2018 BOND PROGRAM HARRISBURG SCHOOL DISTRICT #7

LIFE SAFETY PLAN - HS

AS-BUILTS

PROJECT #	DATE
18015	08/30/2019

FLOOR PLAN - HS
BUILDING 8 EAST

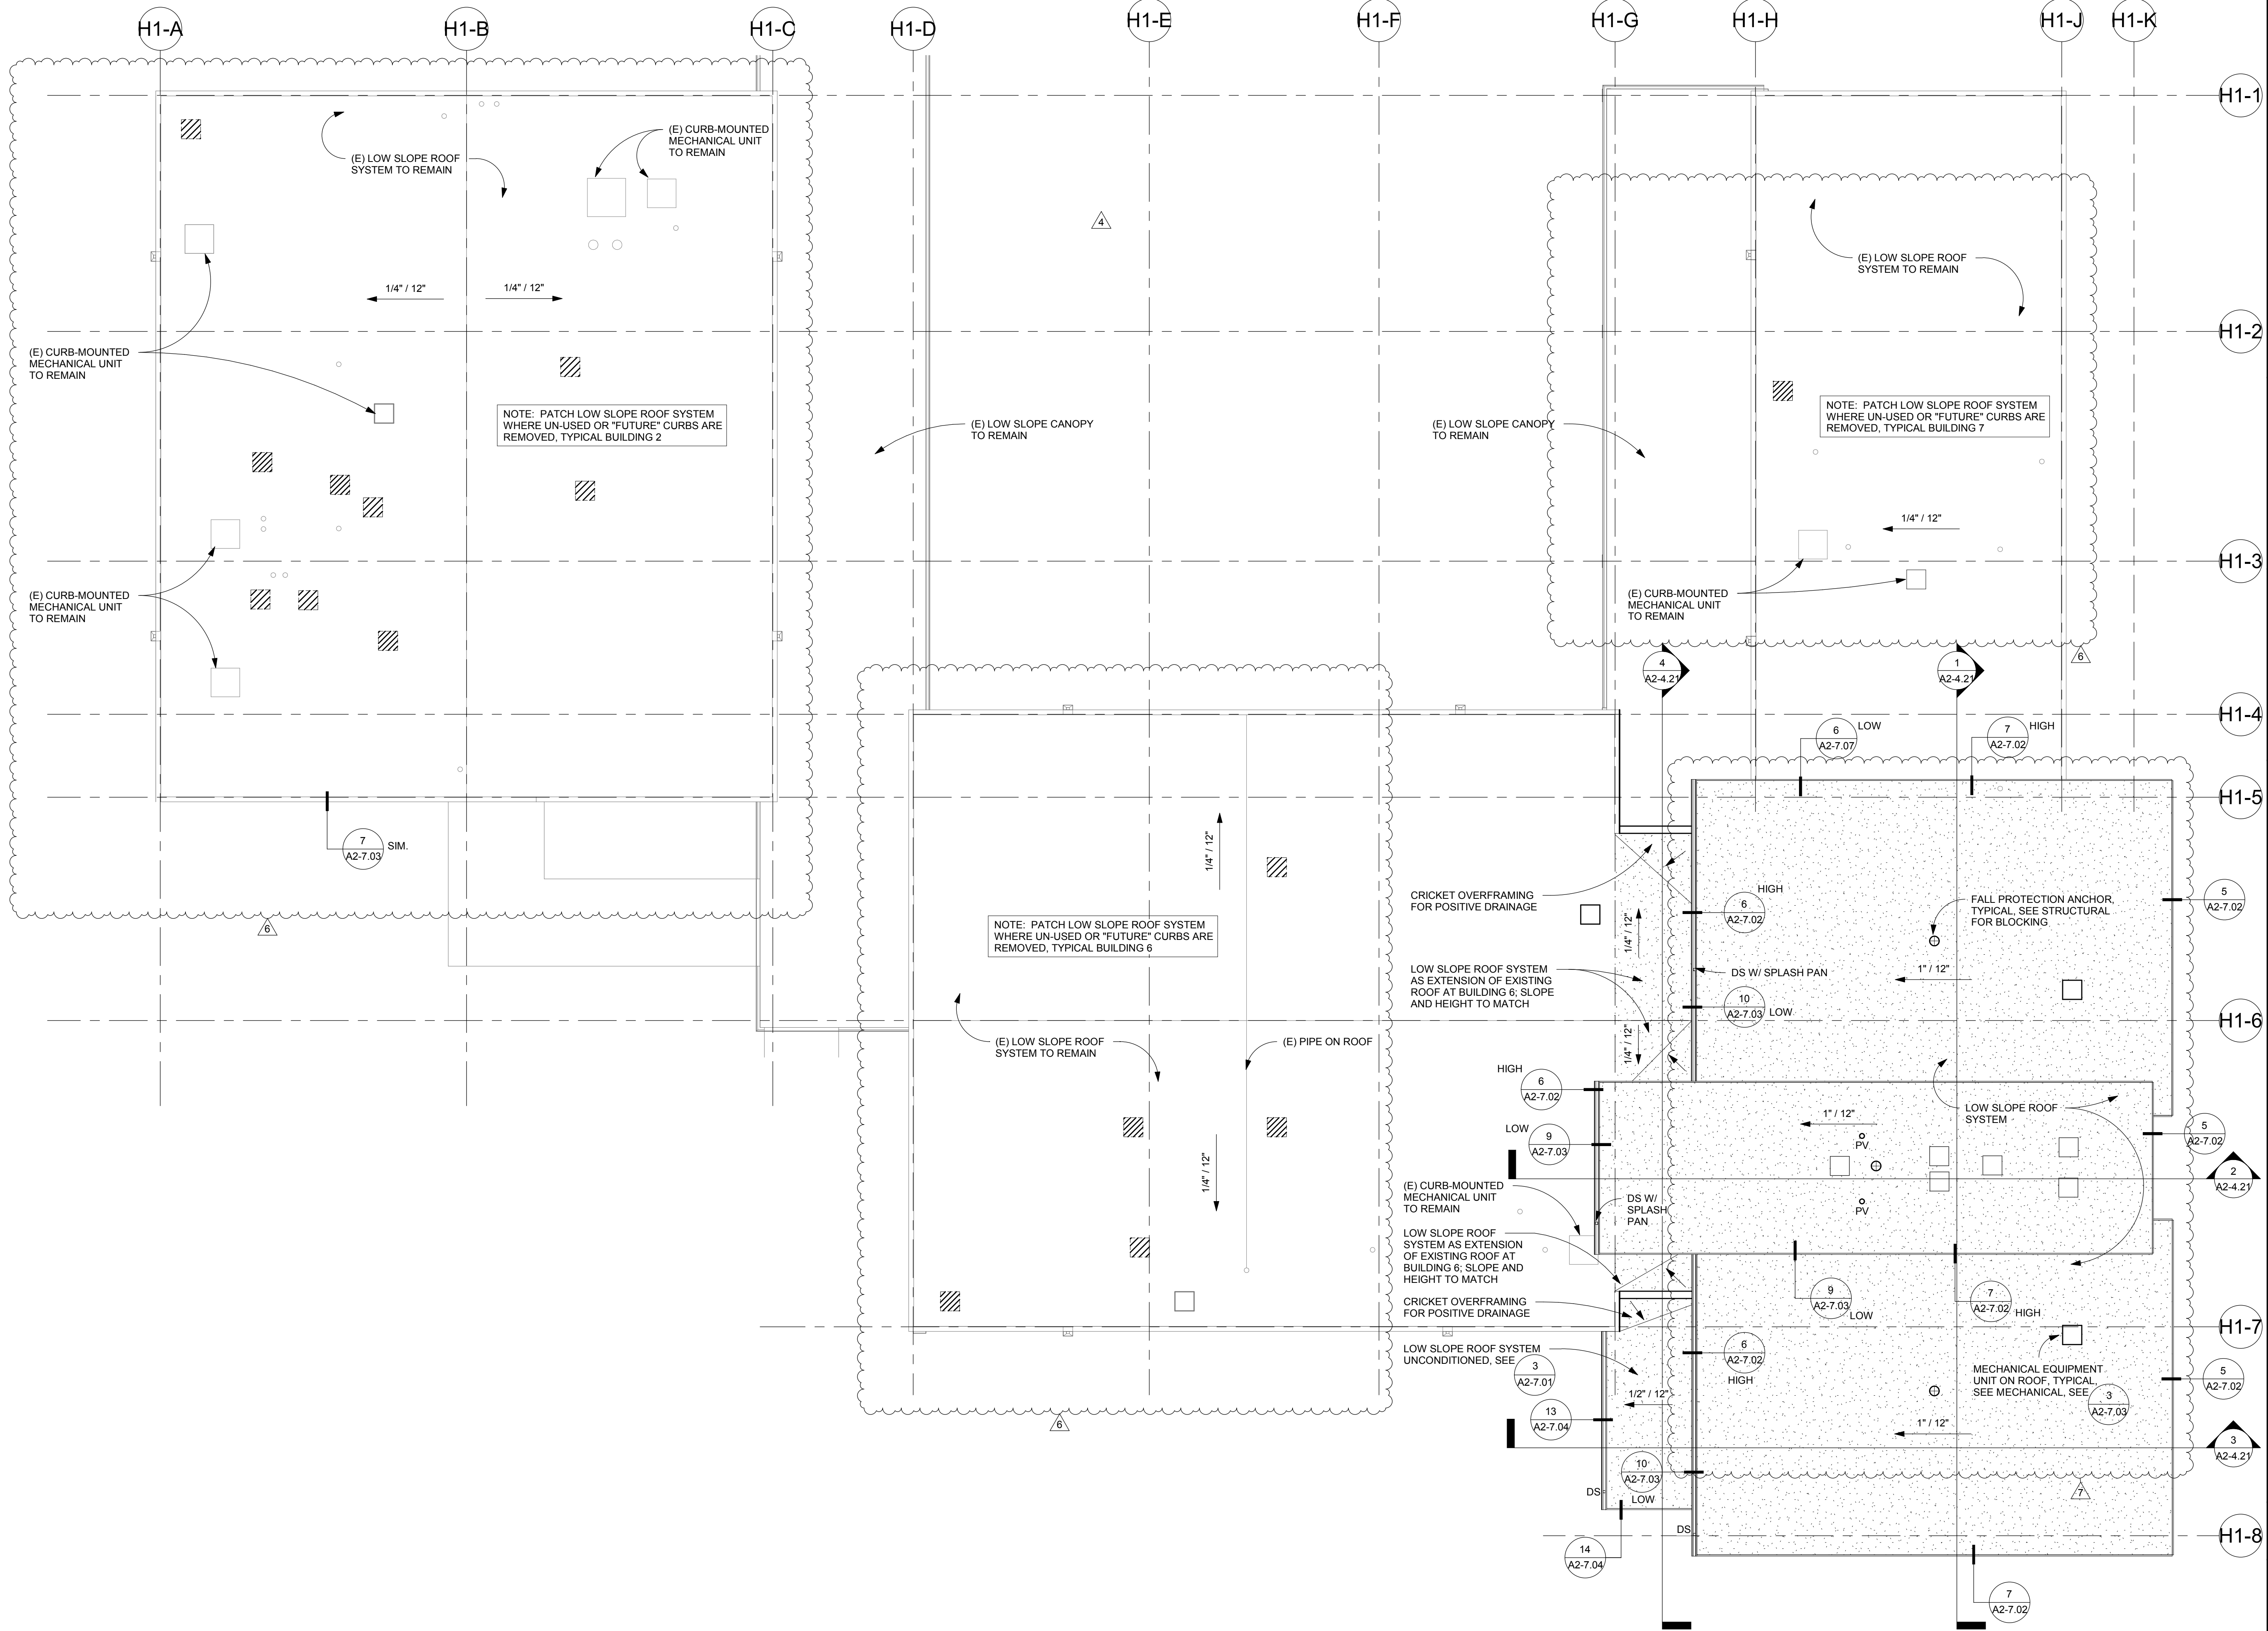
Size and layout
change per RFI 50
